WOLLONGONG CITY COUNCIL

# Traffic Committee Minutes of Meeting

14 November 2023

Item 4.2 - LAKE HEIGHTS, Northcliffe Drive – Proposed Pedestrian Refuge & Channelised Right Turn Lane - Page 2 of 4

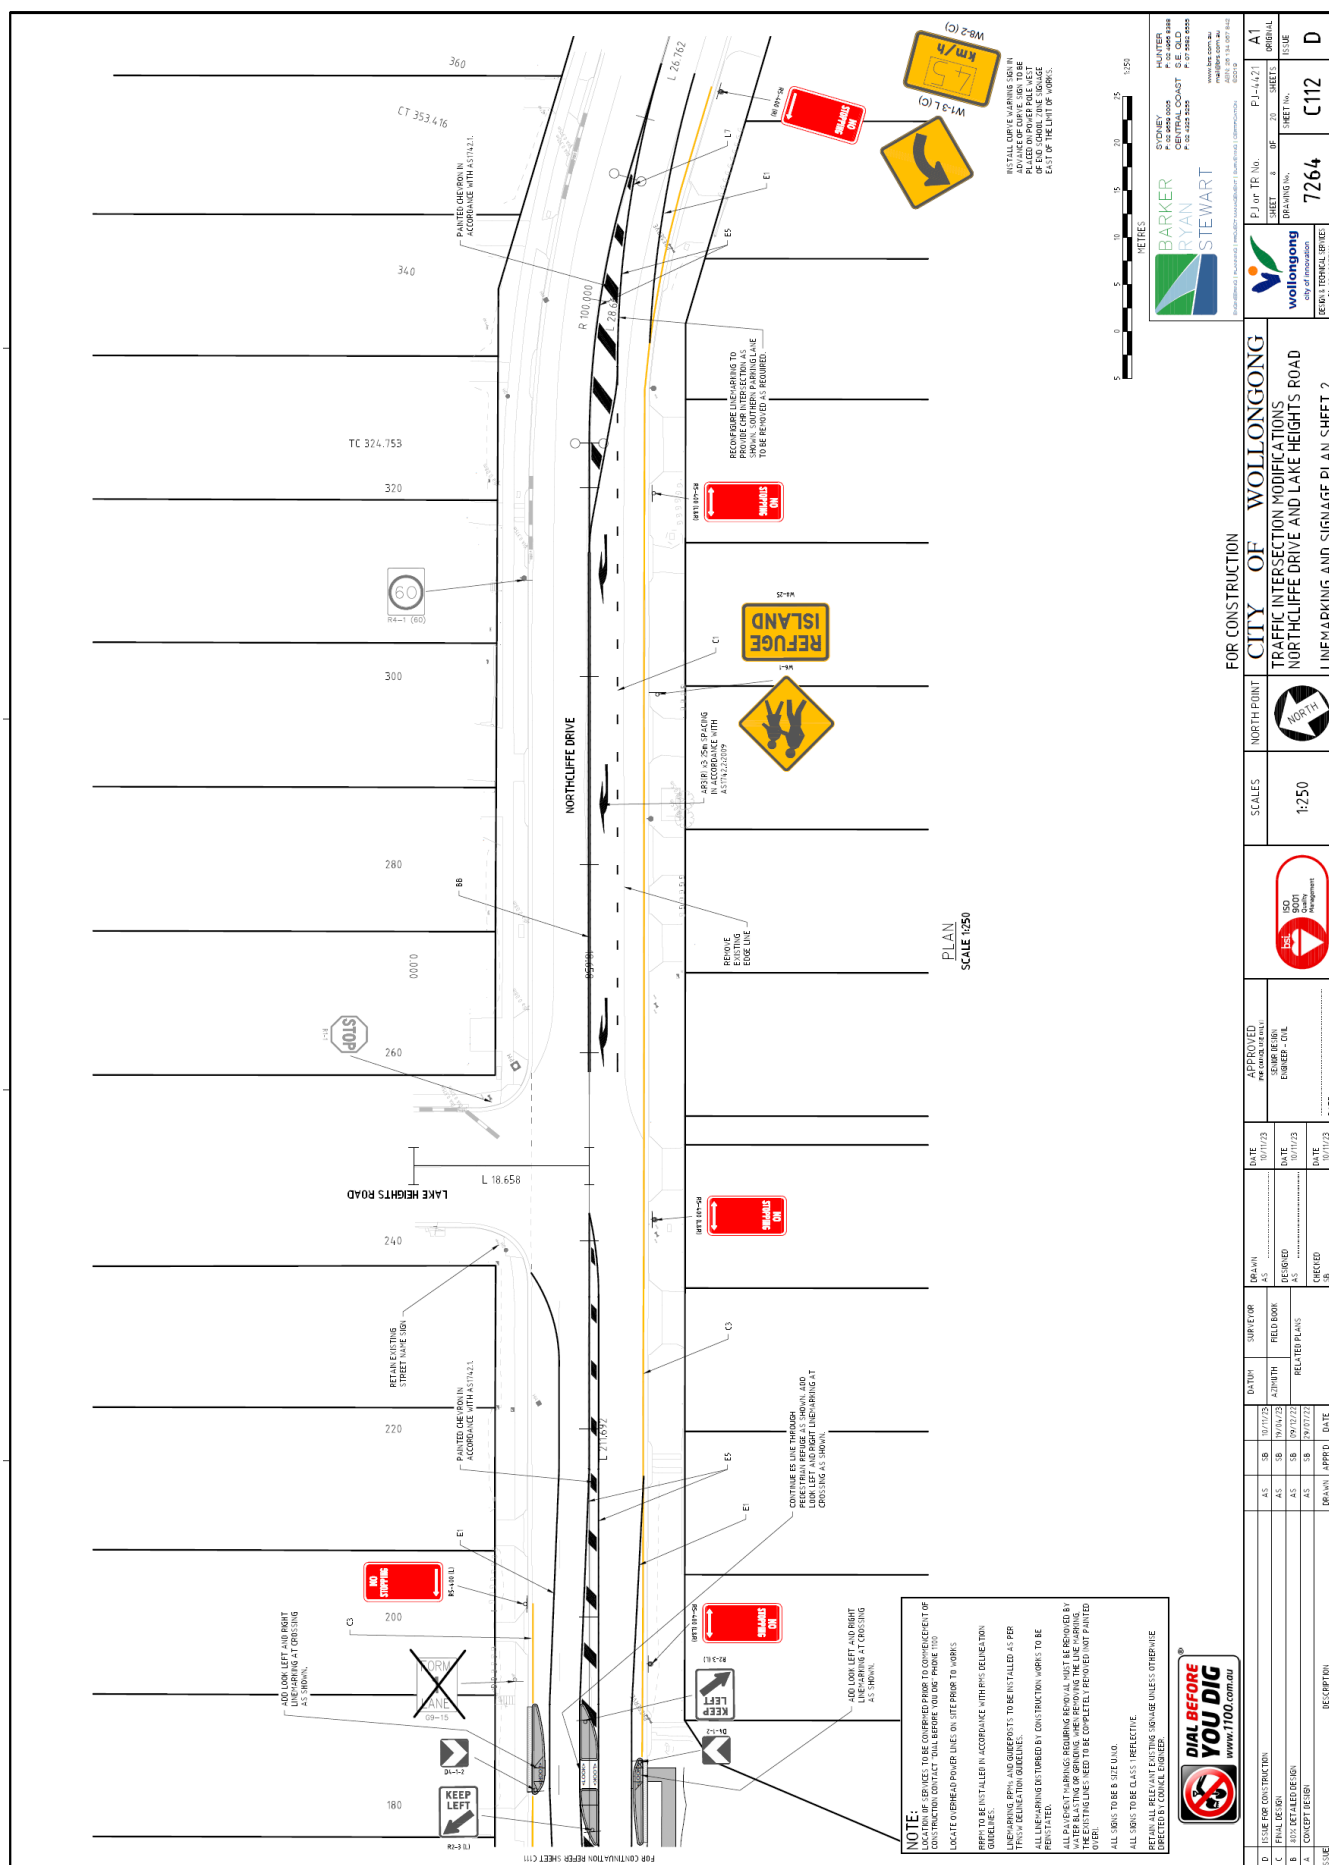
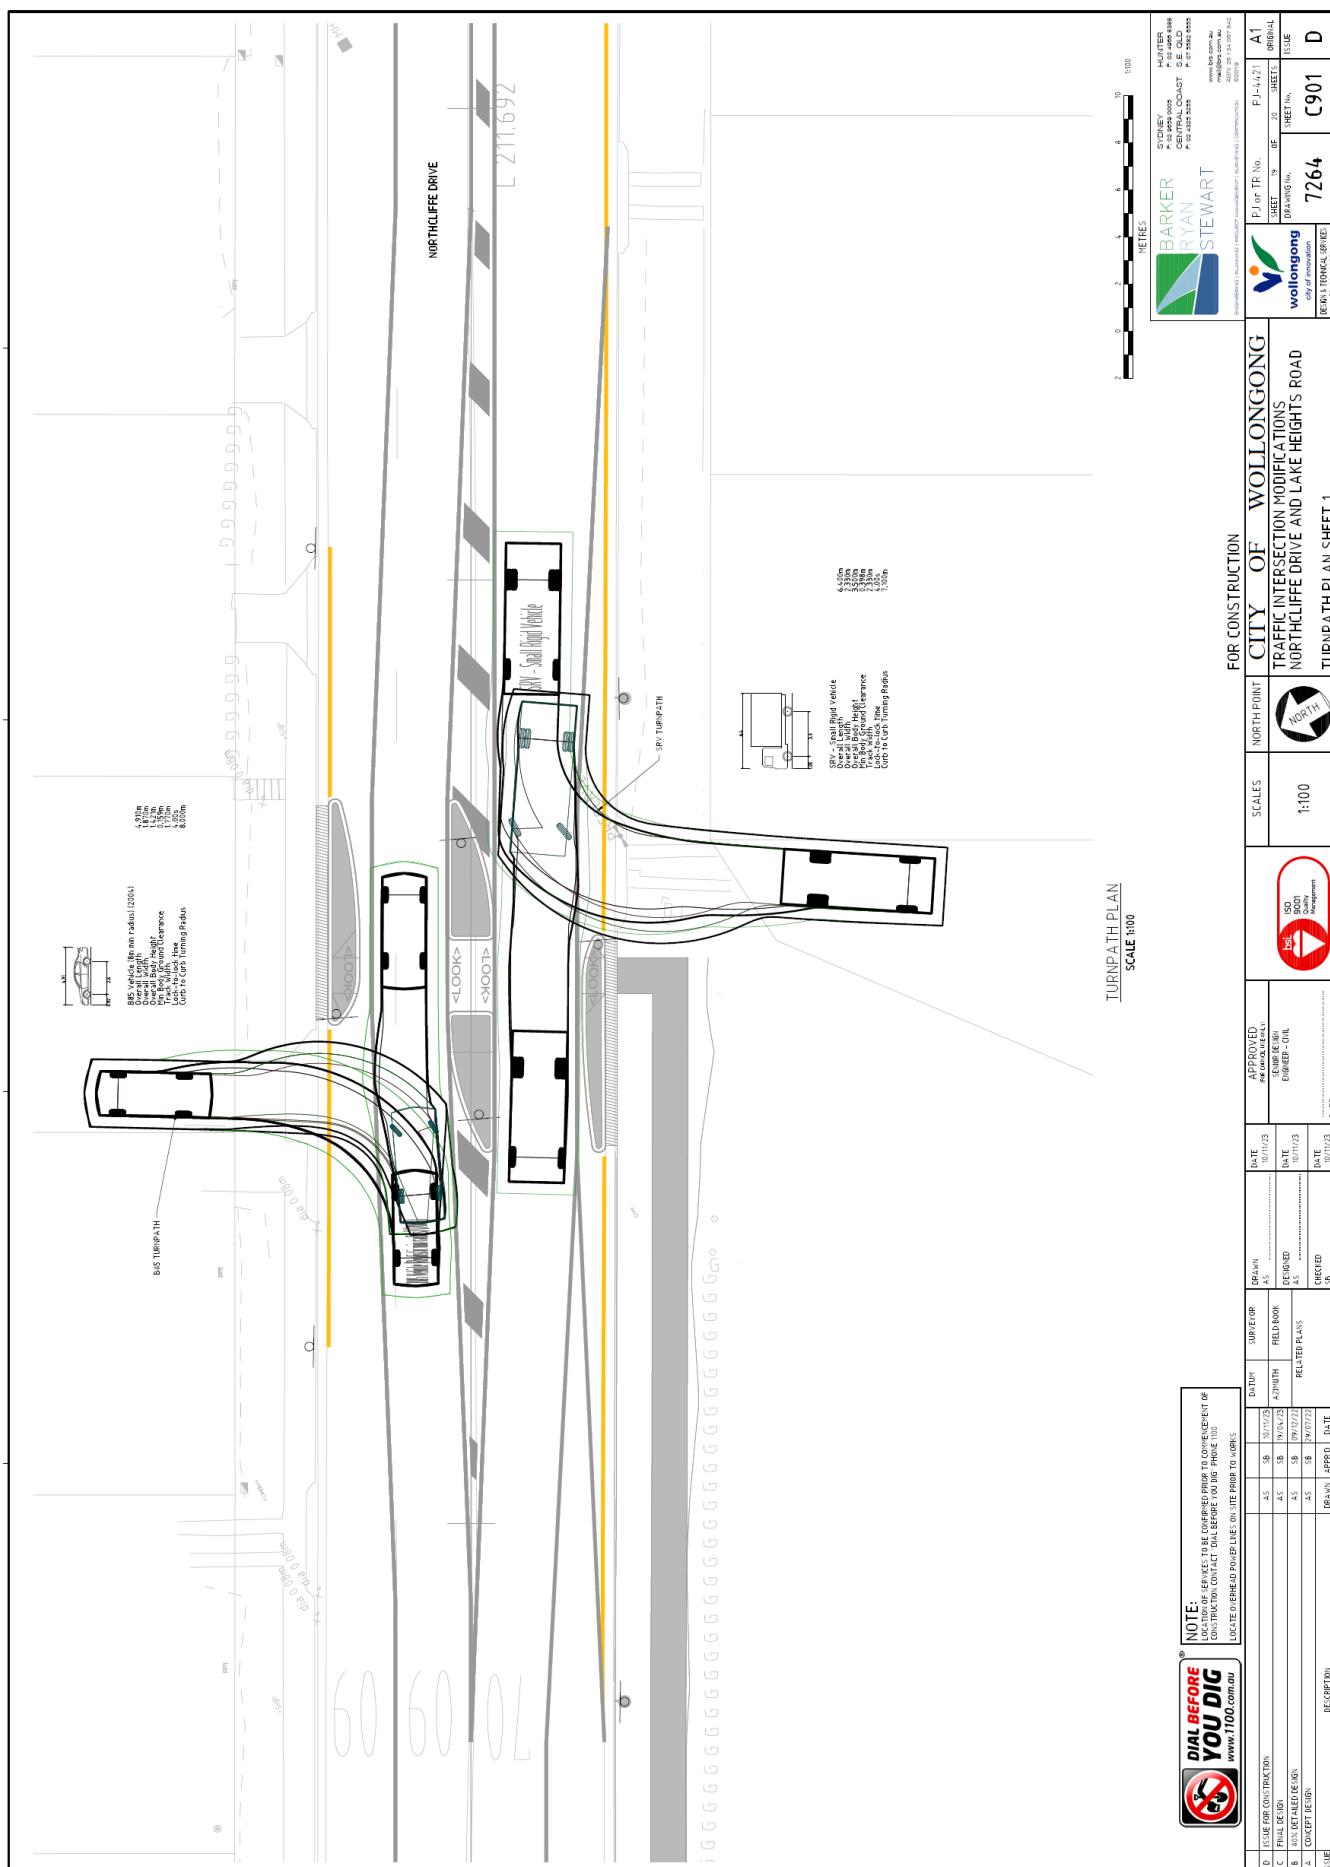
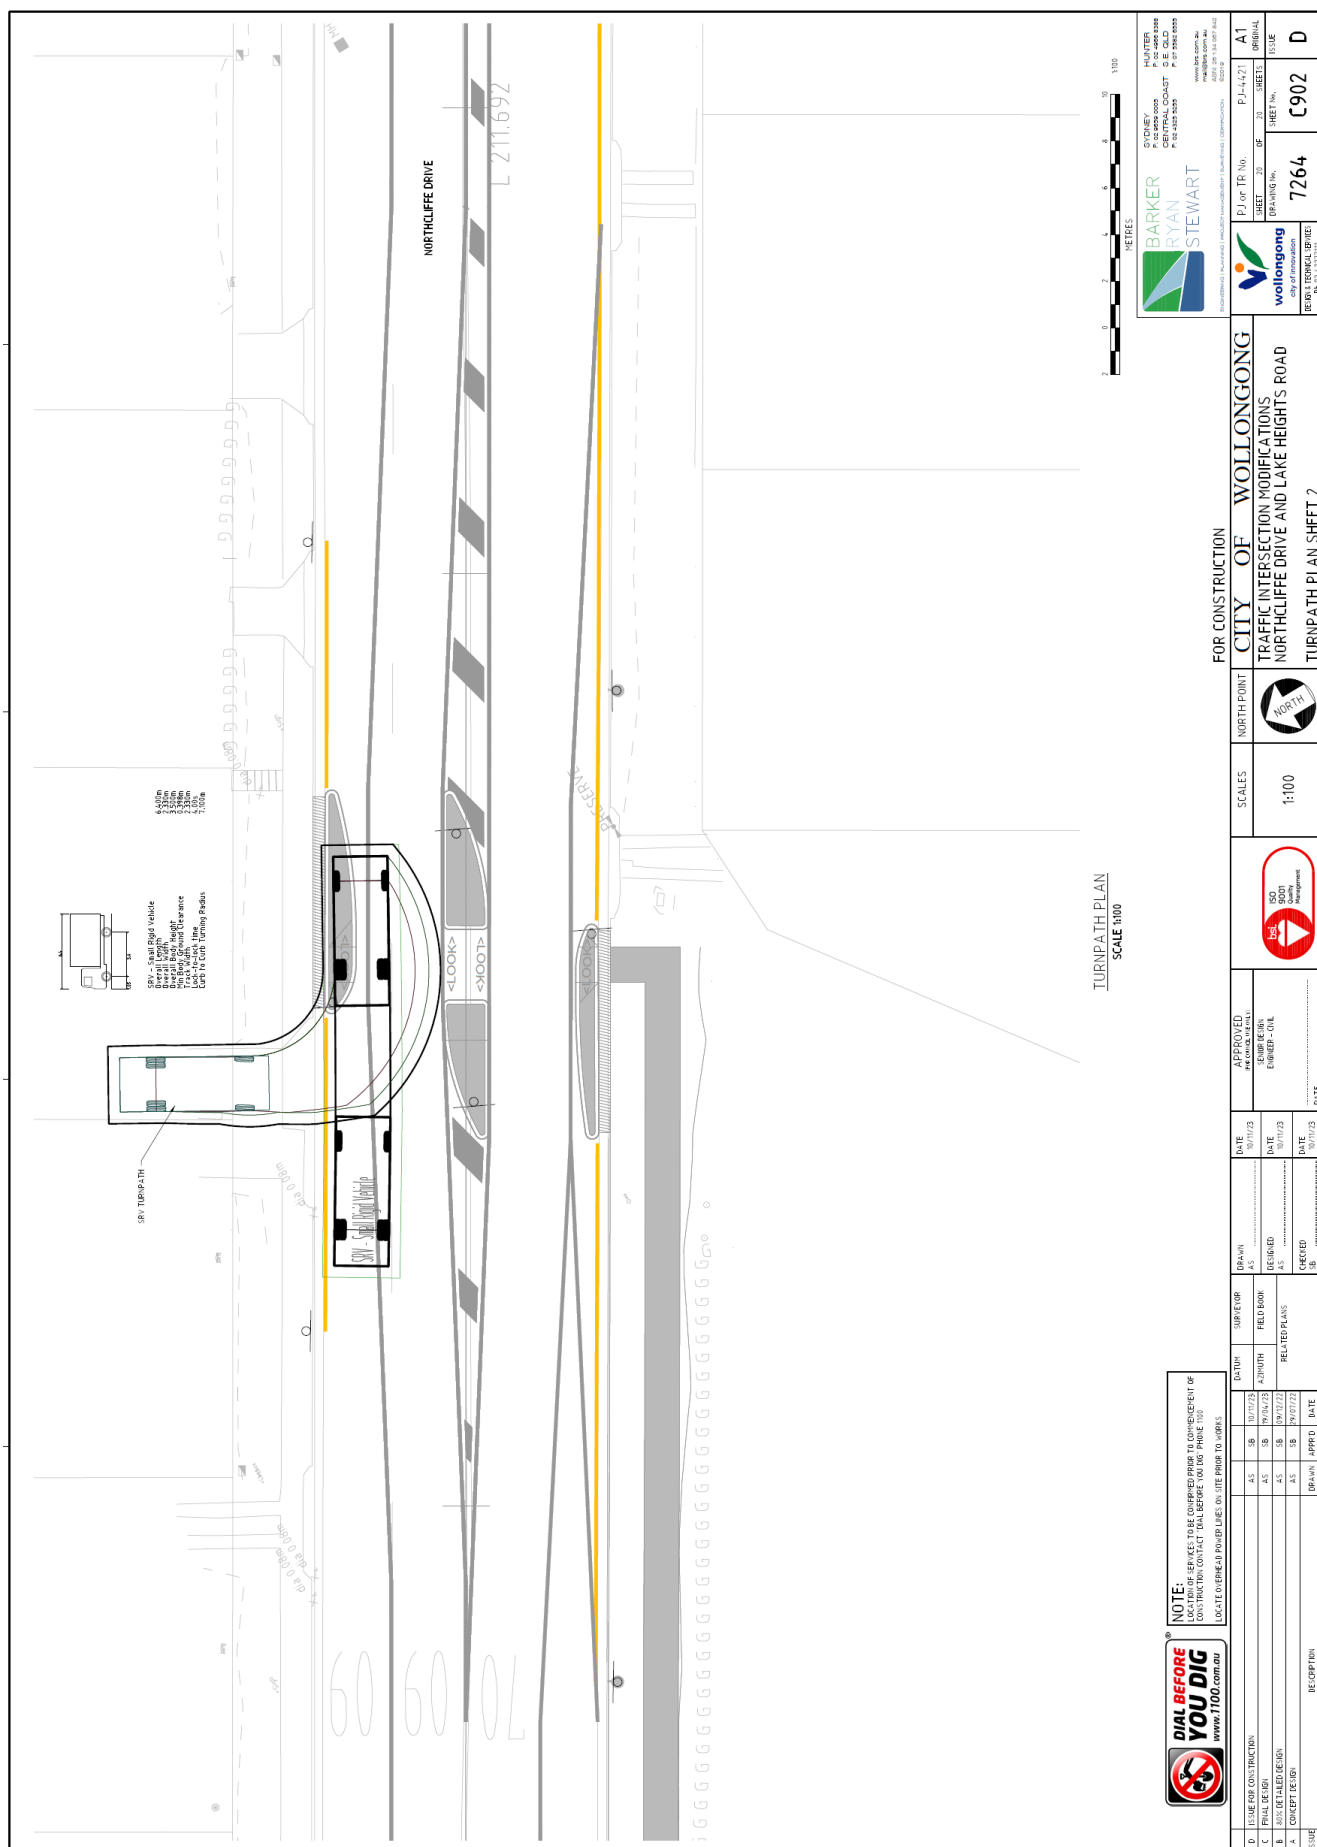
The channelised right turn lane treatment has been designed in accordance with Austroads requirements Part 4B. Details of the intersection geometry are shown on the design plans and are listed below:

The attached plan be approved subject to:

1. Bus zone signs being installed at Bus Stop ID250213 (northern side of Northcliffe Drive, east of the Lake Heights Road T-intersection) to provide greater clarity of bus zone existence at location.
2. Council considers the installation of a No Right Turn sign at Lake Heights Road following Police concerns of sight distance issues at location. The installation will be subject to a Council investigation in the area considering road safety, alternative routes, and sight distance at the alternative intersections.
3. Transport for NSW being notified of proposed installation dates once community consultation is finalised.

Item 4.3 - HORSLEY, West Dapto Road – DA-2017/1124: Proposed Interim Intersection Design

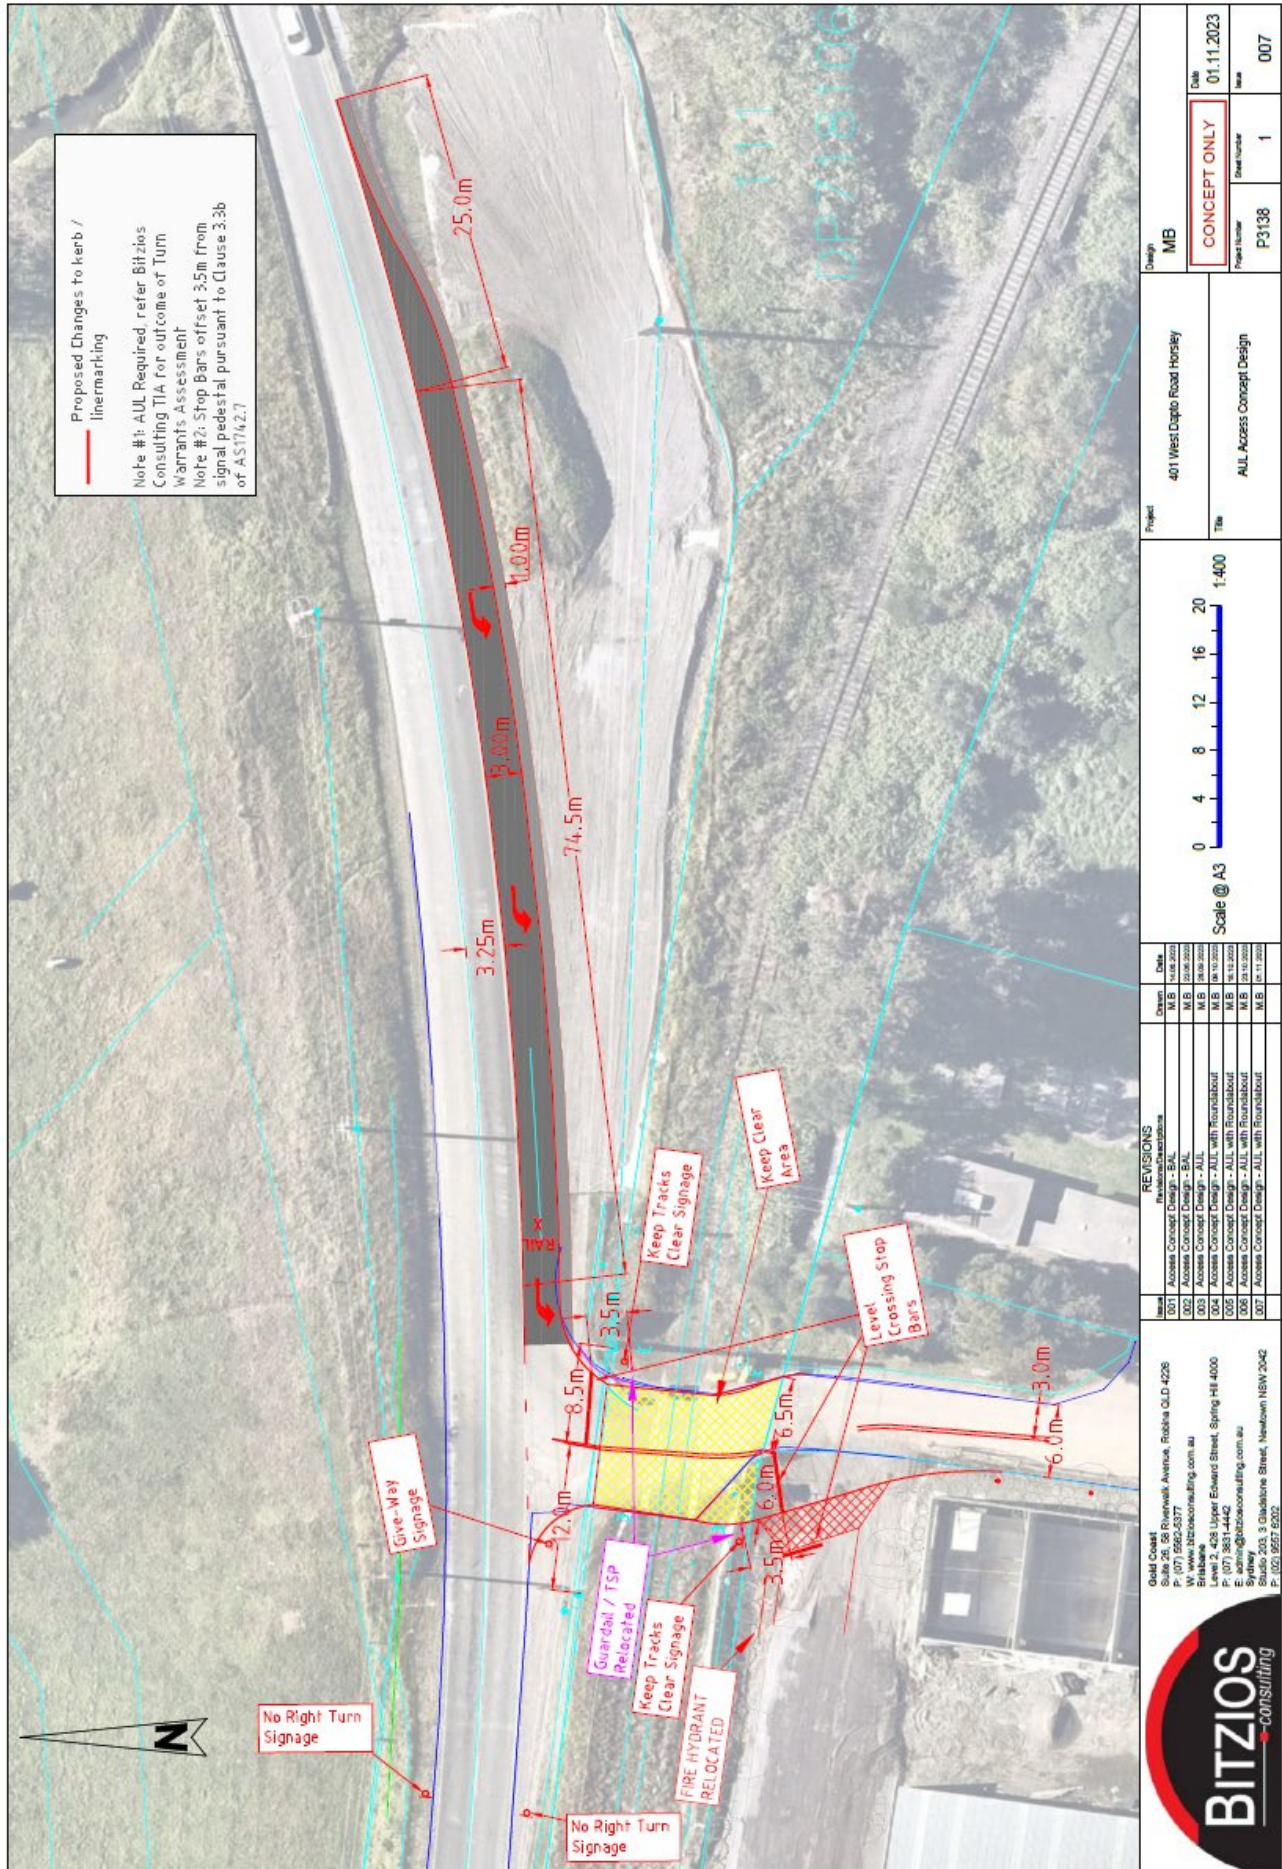
The site is 401 West Dapto Road, Horsley. On 17 December 2018 a DA (DA-2017/1124) was approved for 65 Self Storage Units and Improved Road Access. Council is upgrading West Dapto Road in the future and will provide a roundabout at this location which would also provide the ultimate intersection/private access to the development. Due to the length of time needed for utility relocation approvals and land acquisitions the process is expected to take approximately 2 years.

In order to gain access to the site in the interim, a modification application was submitted and approved (DA-2017/1124/A) and has prepared an interim access solution which will be in place for up to 2 years, by which time Council or the developer will construct the roundabout and tie into the existing modified access across the rail line. No further works within the applicant's site would be needed to construct the roundabout. This item is for the interim access proposal only.

That the attached plan AUL Access Concept Design, P3138, issue 007, prepared by Bitzios Consulting, dated 1 November 2023 be approved subject to:

1. The findings from the independent Road Safety Audit being actioned where necessary.
2. An operational condition be placed on the modified Development Application stating that, all drivers accessing the development must not turn right into the development in a westbound direction. Drivers are expected to utilise Darkes Road/West Dapto Road intersection in the interim until the ultimate intersection design is complete.
3. The existing roadside barrier (located where the interim AUL is being proposed) be relocated to preserve road safety at location.
